Applicant: Lectrosonics, Inc.
581 Laser Road
Rio Rancho, NM 87124

Re: Response to Correspondence reference number 31724

Equipment: FCC ID: DBZUM450M, 731-confirmation number EA158081

Photograph showing separation distance from the back of equipment to the antenna.

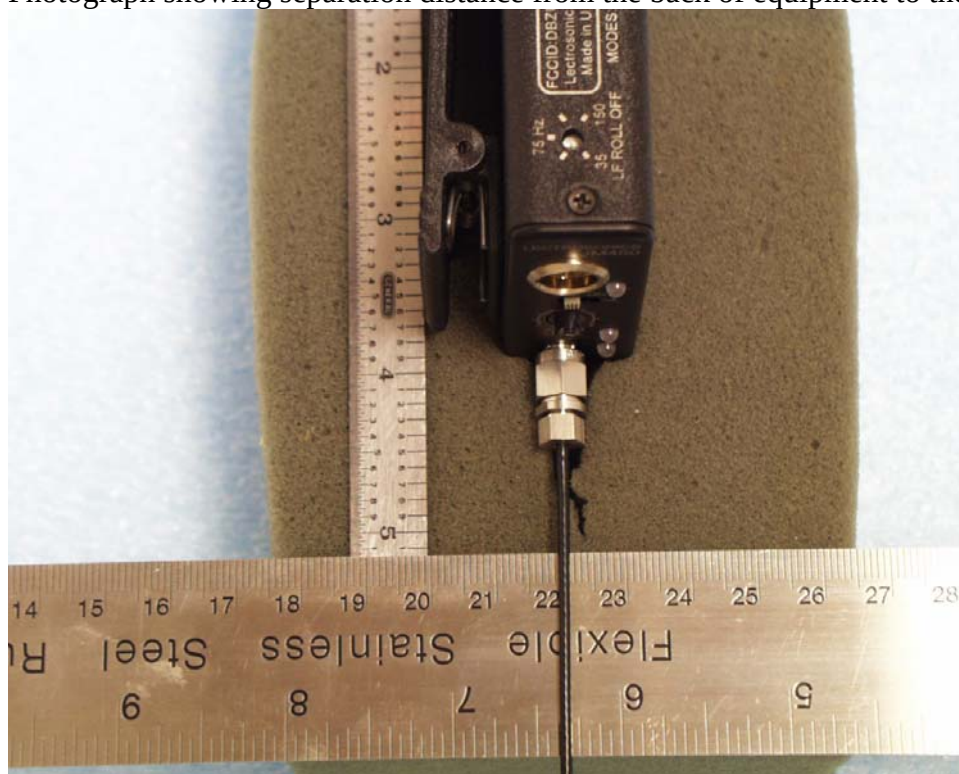
To support FCC RF exposure compliance determination, please submit photos and/or sketches for product with antenna installed showing spacings between the plane of the back of the belt-clip to: a) the back of the device, b) the closest point(s) of installed-antenna(s) FCC will then review all filing info to determine whether other info may need to be requested to support compliance with RF exposure requirements as applicable for all transmitters regulated by FCC. It may help to expedite this review if applicant has available and wishes to voluntarily submit SAR test results for this specific product

Below please find relevant photographs per your request demonstrating spacing between the back of the device and antenna, and the back of the clip and antenna.
